RESOLUTION NO. R-2535

FILE NUMBER P-PUD-78-25(P)
APPLICANT Ron Stewart, Cambrian Development
PROPERTY LOCATION 9th Ave. S. and 10th St. S.
SUBJECT PRELIMINARY PLANNED UNIT DEVELOPMENT OF "SUN DANCER"
HEARING/MEETING DATE June 19, 1978
BEFORE KIRKLAND CITY COUNCIL

To: Kirkland City Council
From: Jerry Link *Link*
Subject: Sundancer PUD-78-25(P)

Subject: Development of Access Road to
the Sundancer Planned Unit Development

EXHIBIT C
 Site Plan
 P-PUD-78-25 (P)
 "SUNDANCER"

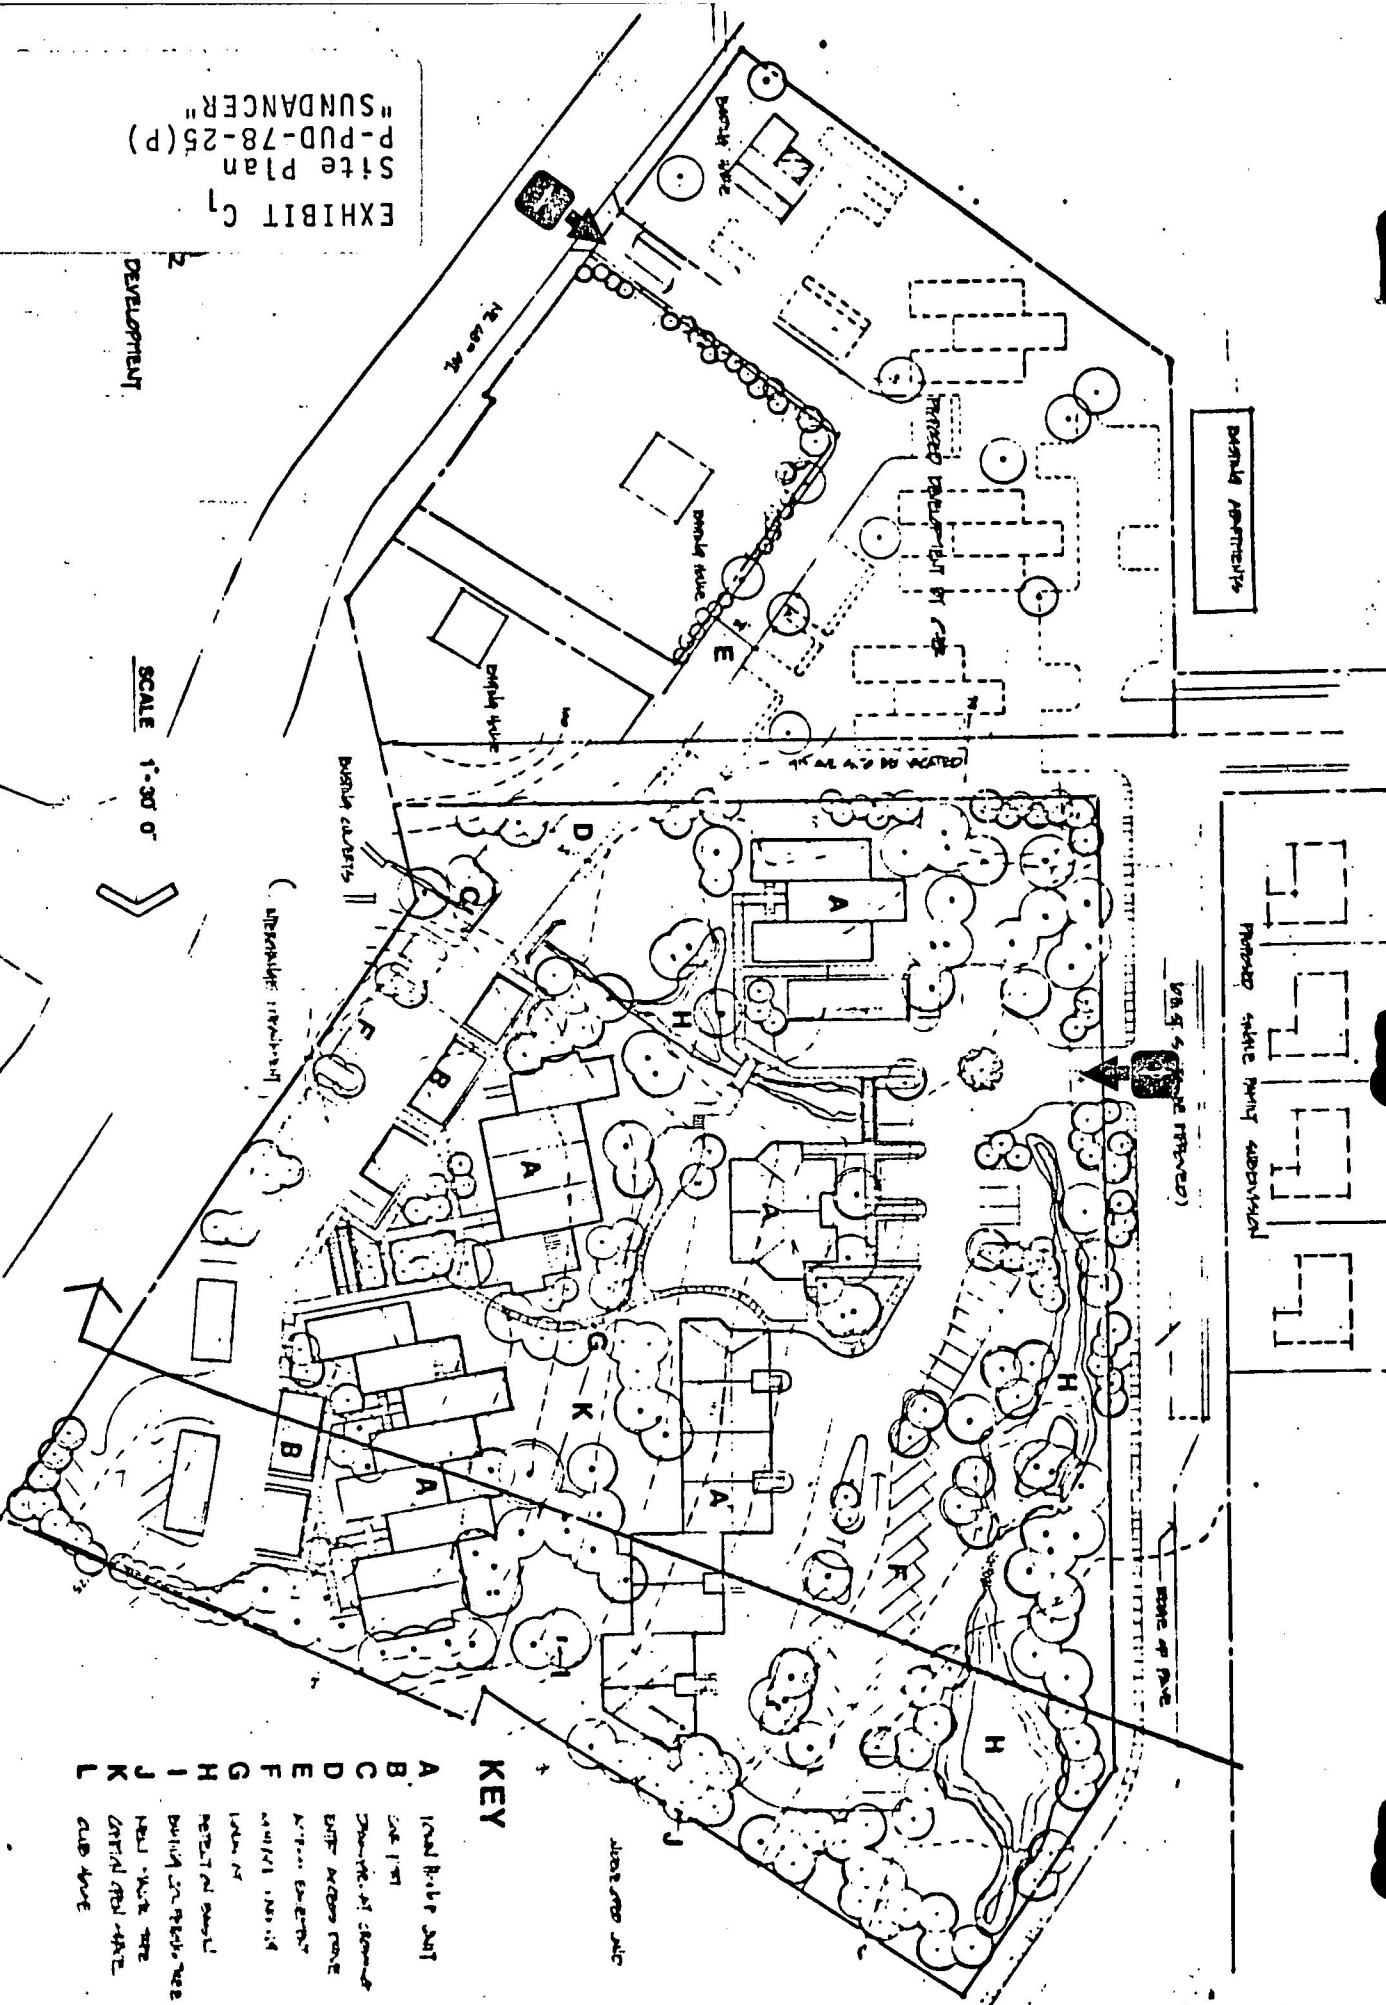
9. Domestic Water/Fire Hydrant. The applicant should indicate that there is adequate fire flow per the requirements of the Kirkland Department of Fire Services. They should also indicate on their revised Exhibit "D" (Grading/Utilities) that the four fire hydrants will also be installed.

10. Sanitary Sewer. The applicant should revise the sanitary sewer drawings to conform to the configuration indicated by the Public Service Department.

However, some revisions to the site plan would be appropriate in order to more fully address policies in the Land Use Plan. These redesigns should minimize the percentage of impervious surface on the site, as well as provide a greater degree of buffering for the single family areas to north and to the west. This can be accomplished by:

- a. Redesigning the parking areas on the western portion so that the open asphalt areas are more broken up with berms and landscaped islands.

5. Applicant shall indicate on the final site plan where additional earthen berms and landscaped islands will be added to further "break up" the open asphalt area.

CDT-SUNDANCER ACCESS DRIVE

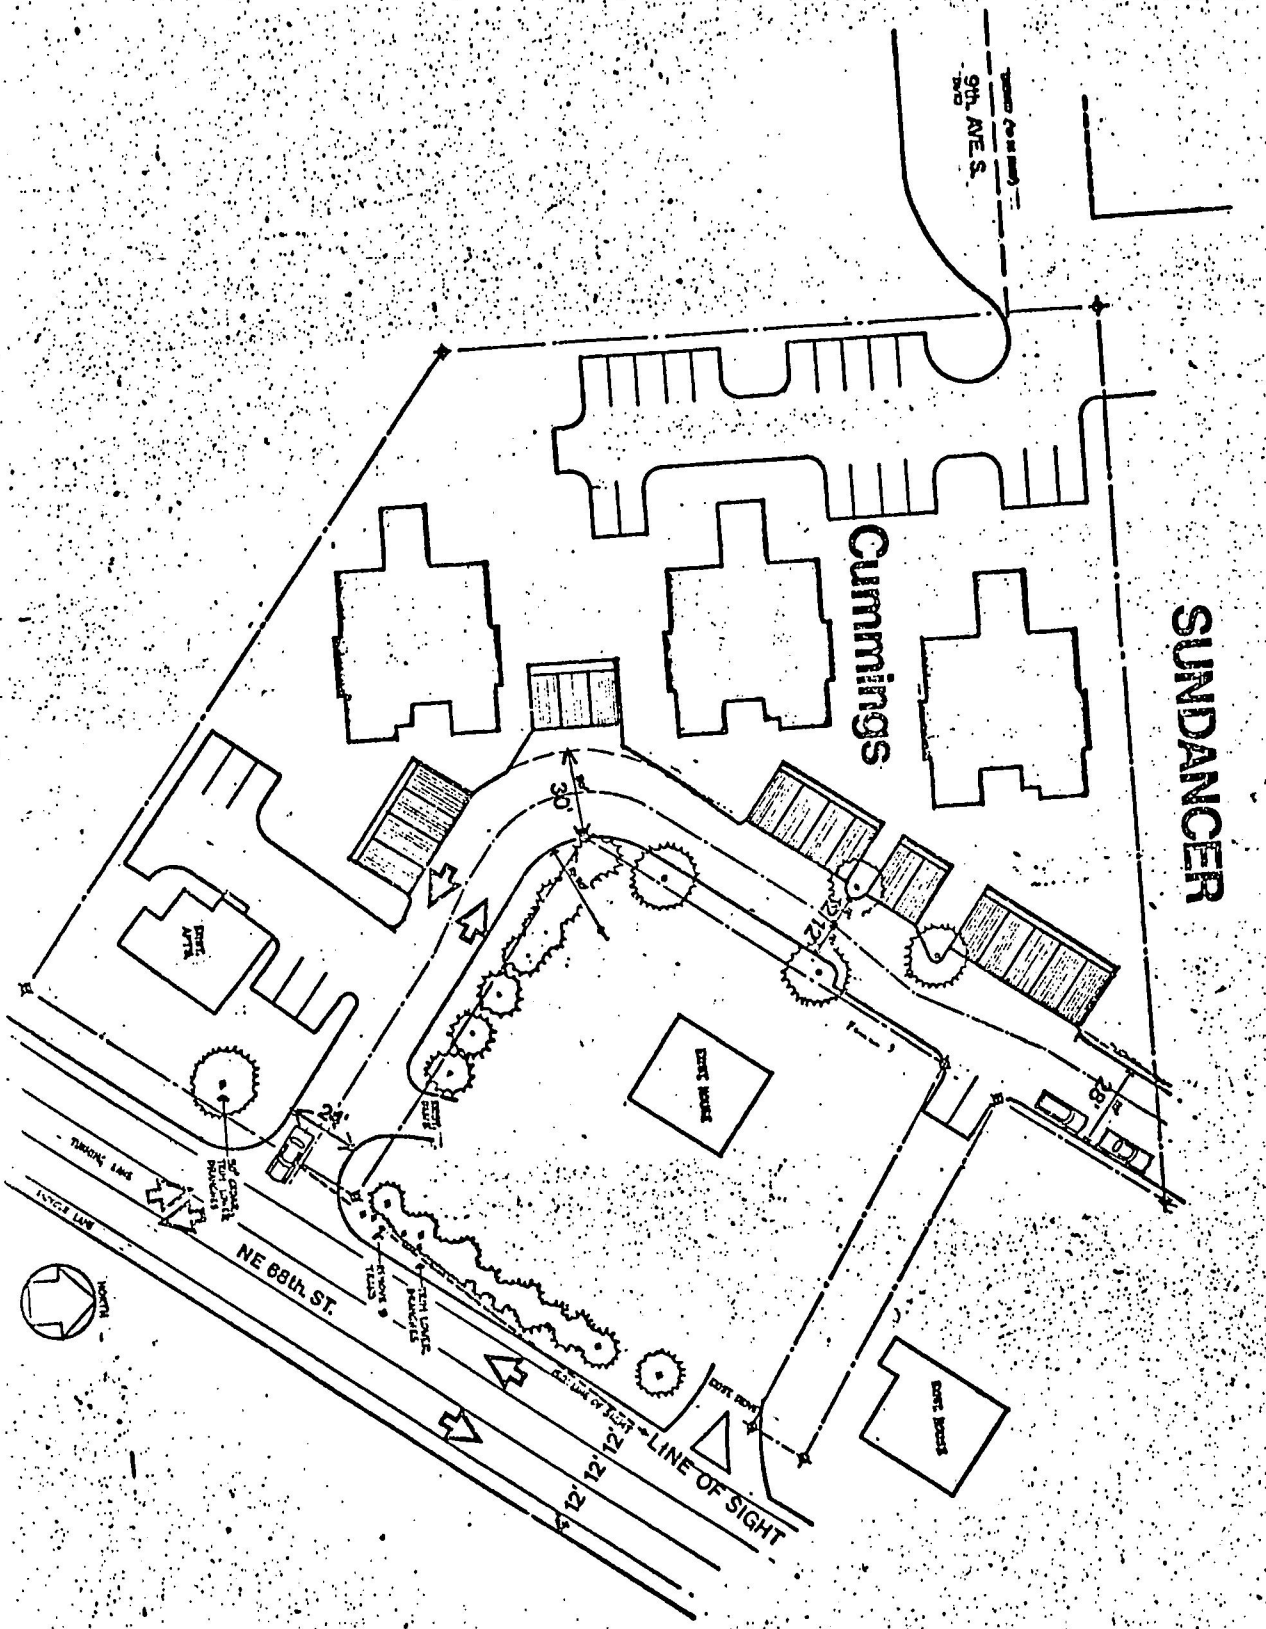
- 2) Circulation on interior private road. The City Council expressed concern over the width of the private road, the provision for guest parking, and the negotiability of turns both at the throat along N.E. 68th Street and where a 90° jog occurred. The applicants have responded to these concerns as illustrated on the attached drawing.

The radii for the two turns have been adjusted after consulting with the Public Service Department. The width of the 90° jog has been widened to 30 feet and the geometry of the road reworked so that a true 90° turn does not occur. The applicants have provided for two 12 foot driving lanes along the greatest part of the private road (with no parking signs) which flares to 30 feet where the sharpest turn occurs. Where the roadway nears the Sundancer property, the roadway has been flared to 28 feet to accommodate a total of four additional guest parking stalls.

The applicants have attempted to retain a number of significant cedars by the alignment of the roadway.

1. Was a 24 foot wide pavement adequate?
2. Was there a parking problem?
3. Did the 50 degree curve provide proper emergency access?
4. Was the sight distance entering NE 68th Street adequate?
5. Was NE 68th Street a safe street to use as access road?
6. Could NE 68th accommodate 300 cars a day from the development?

1. The city council in a previous development required a 28 foot wide access road and this appears to be proper because:
 - a. Two ten foot traffic lanes and an eight foot parking lane would total twenty eight feet.
 - b. The 1976 fire code being recommended for adoption to city council requires not less than 20 feet of unobstructed width access roadway.
 - c. Guest parking can be accommodated to a larger degree by increasing the original 24 foot width to 28 foot.
2. If there was a parking problem the additional 4 foot in width of paving would solve that problem. The easterly eight feet of the paving should be stripped with one three inch white stripe parallel to and eight feet in from the easterly edge and then identified by signs "guest parking".

3. A 45 foot inside radius would allow for emergency vehicle movements on the 90 degree bend in the road and also 20 foot radius on the flair at the entrance to NE 68th Street.

4. The sight distance was to be improved by the developer and maintained by the city. This maintenance by the city is wrong as that passes on an unwarranted liability. The sight triangle can be so landscaped that maintenance is at a minimum but will be maintained by the developer.
